**From:** Michael Groves <michael.groves@enerveo.com>
**Sent:** 19 February 2025 14:58:47 UTC+00:00
**To:** "Graham Brazier" <graham.brazier@bellway.co.uk>
**Subject:** RE: Elizabeth Sq., Durrington - [EVO20014691] LPA Lighting Queries

**From:** Graham Brazier <graham.brazier@bellway.co.uk>
**Sent:** 17 February 2025 18:35
**To:** Michael Groves <michael.groves@enerveo.com>
**Subject:** Elizabeth Sq., Durrington - [EVO20014691] LPA Lighting Queries

Further to our telephone conversation earlier today regarding the above, below is a copy of the request for further advice concerning the direction and light spill received from the Planning Officer following submission of sheets 1 & 2 of the Section 278 & S38 Street Lighting Layout Drawings –

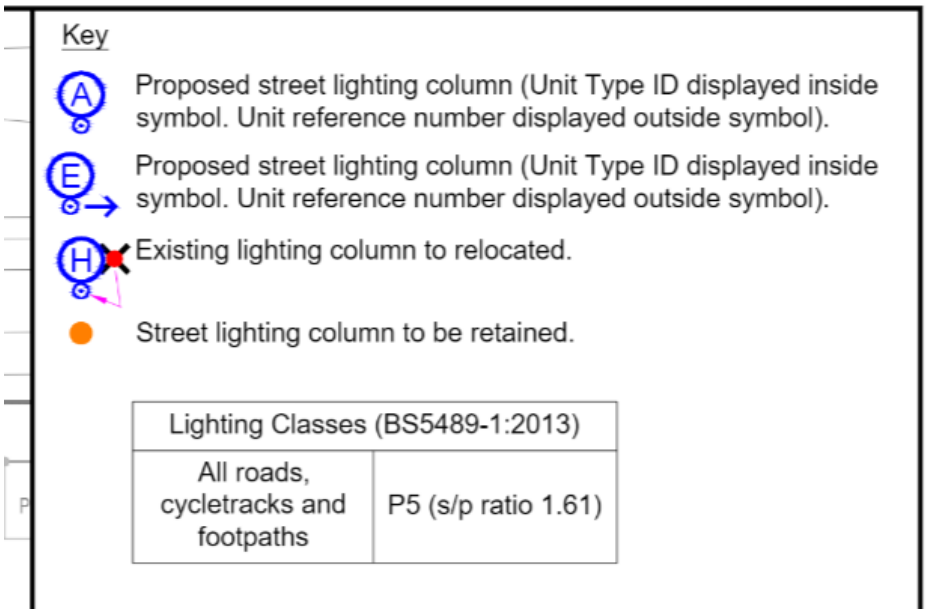
> Regarding implications for light spill and neighbours, pl can your consultant advise me about the specifications below? For instance the luminaire tilt, is the 5 degrees needed where lights are angled away from neighbouring windows, to what extent does optic setting and wattage affect light spill?
>
> I've included the screenshots, including the symbols below. Pl can they explain the use of arrows - does this signify direction?

Query 1: 5-degree tilts have been used to allow us to push the light across the road more when the road widens. Alternatively, a different optic can be used with a wider distribution but sometimes that can cause an adverse effect of pushing too much across the road and into areas where it is not needed or wanted, such as property windows.

Query 2: The arrow indicates the direction of the column folding down mechanism (the direction of which the column will fall down to when it is lowered. Only applicable to raise and lower columns).
